Indicates proposed changes to approved planning application 2019/6088/P and approved LBC 2019/6270/L

Client  
Kings Keeley Limited C/o Clearbell Capital LLP  
Project  
65 Kingsway - Base Scheme

Title  
Proposed Fifth Floor Plan

Drawing No.  
**1914-BG-01-05-DR-A-20.207**

01 Proposed Fifth Floor Plan  
20.207 1:100@A1, 1:200@A3

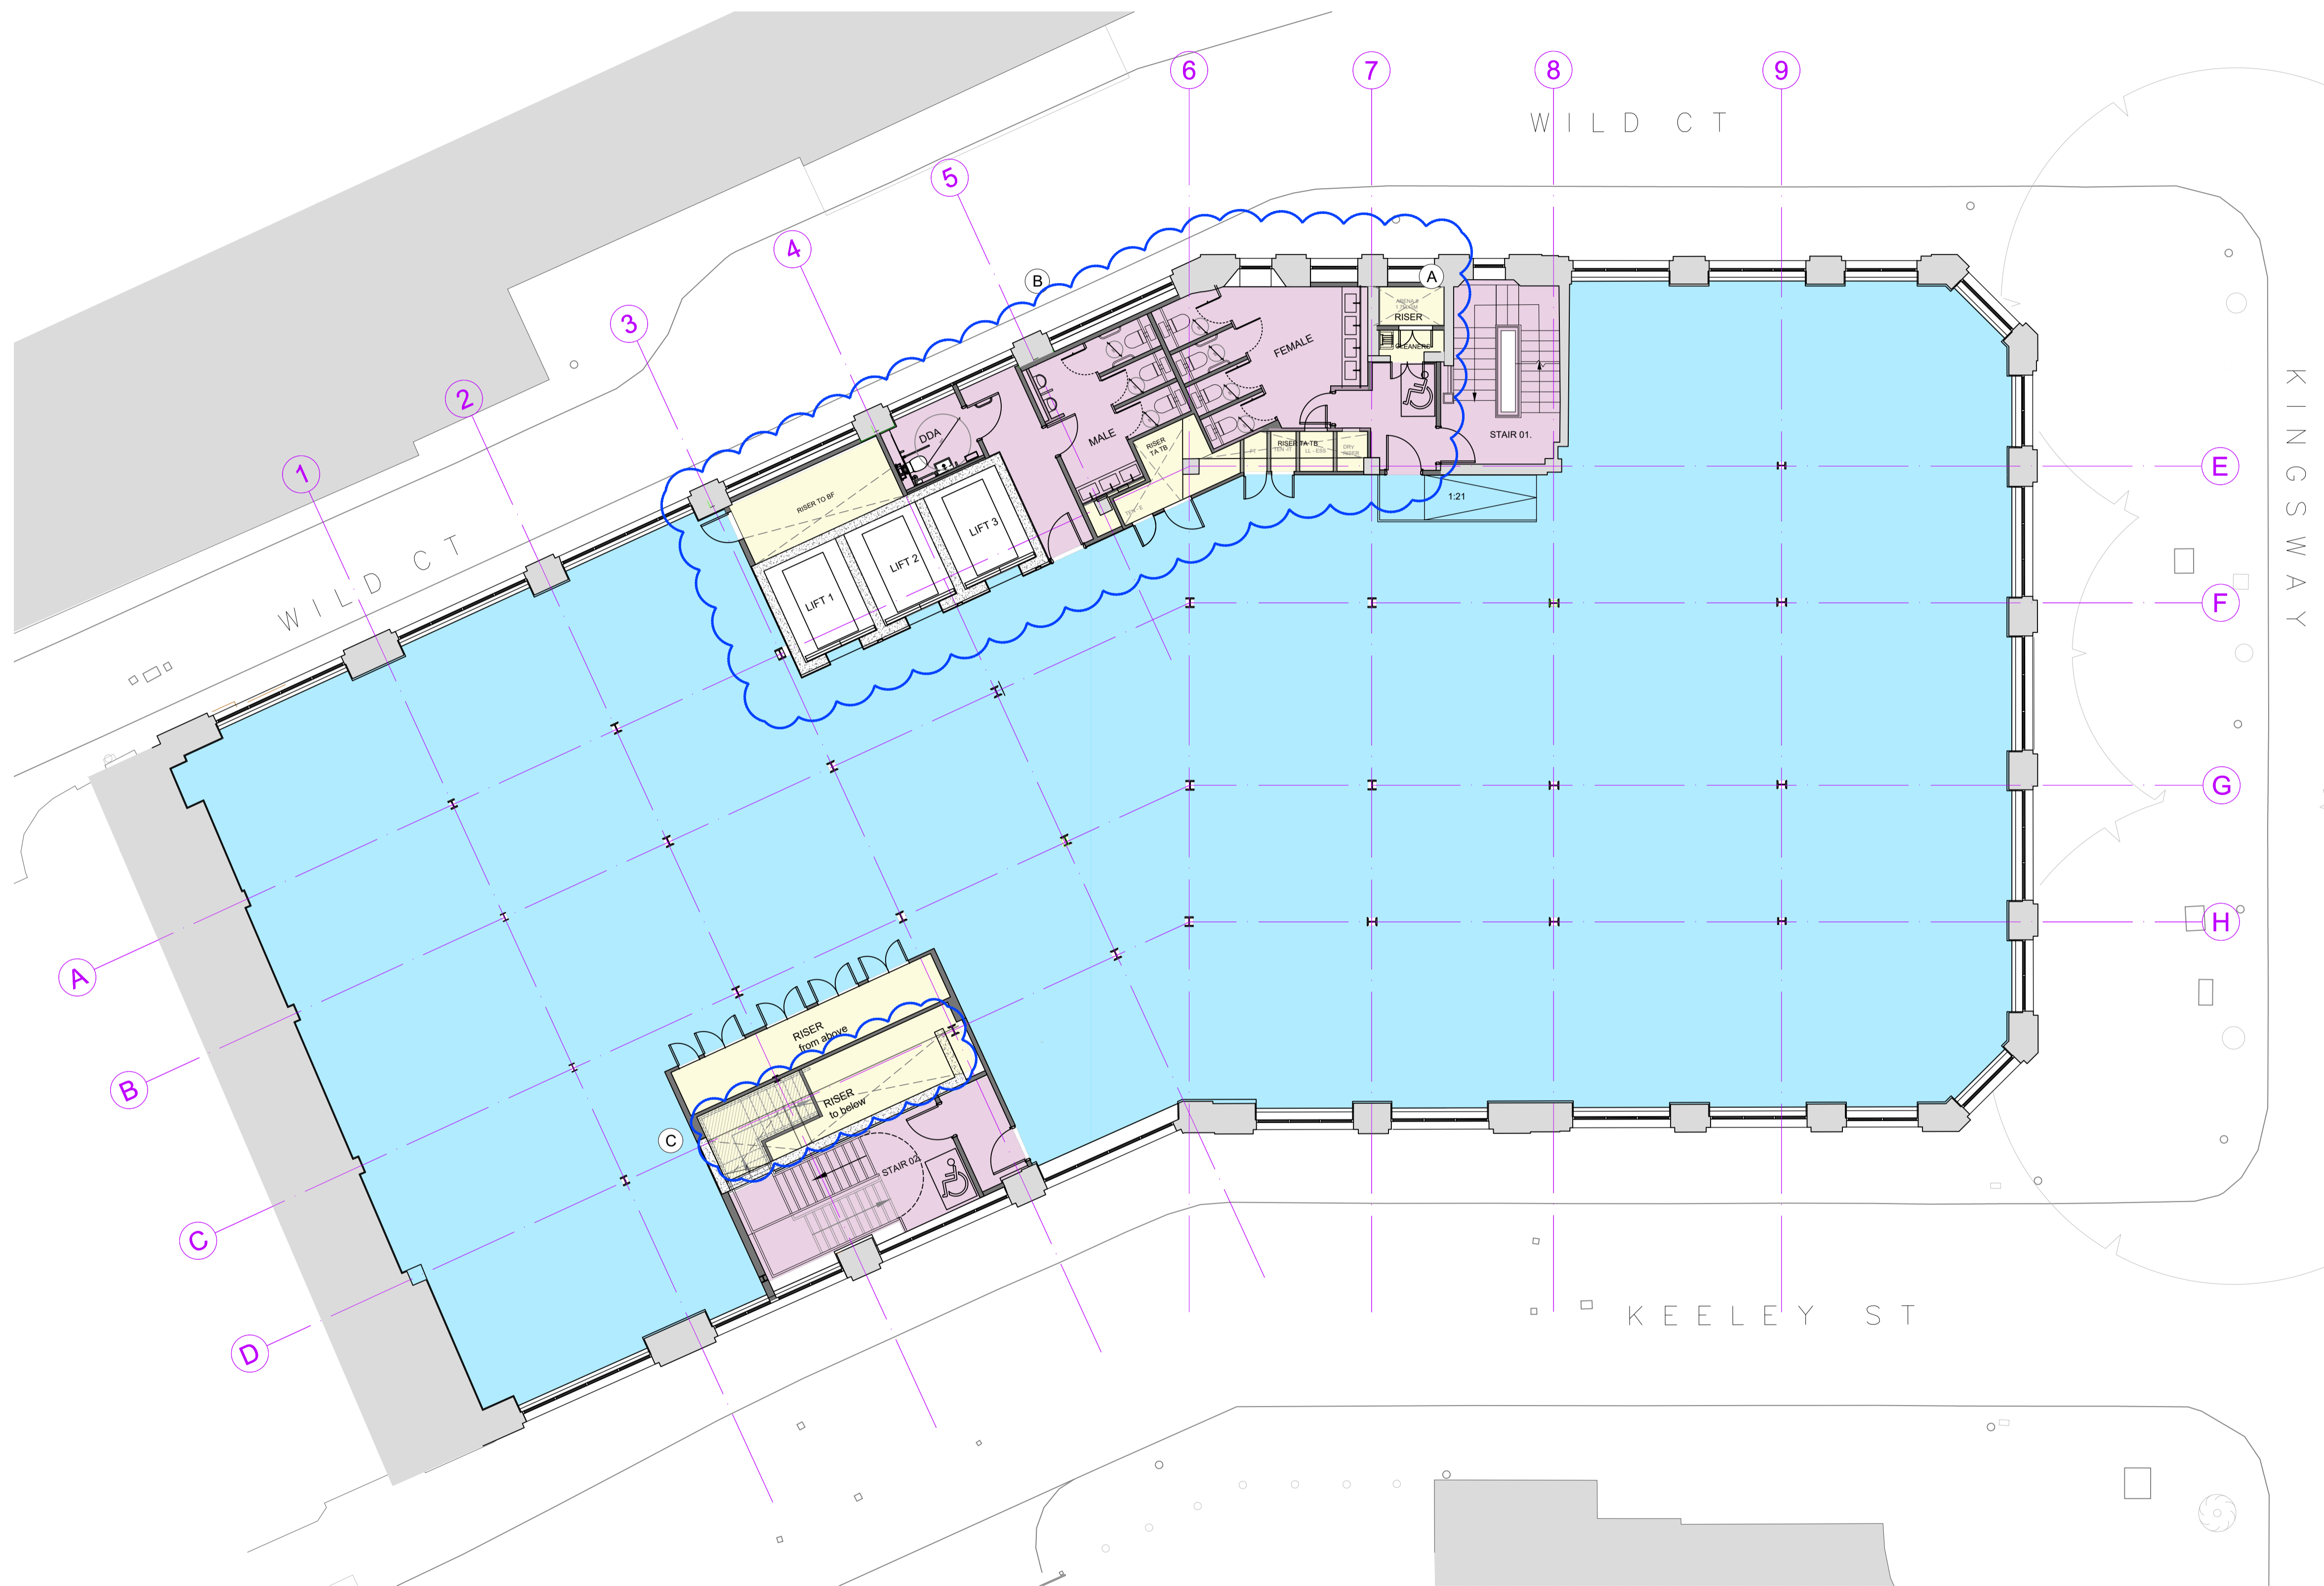
- A. F/F Lift omitted. Riser and cleaner's cupboard in place from second floor to roof.
- B. Revised primary core layout. Lifts shift approx 300mm to GL/5. WC layout amended to suit. Ref drg 20.301
- C. Stair configuration adapted to suit offset of floor levels. Movement of riser and structural core wall Note - no impact on demolition of historic fabric to suit proposed layout..
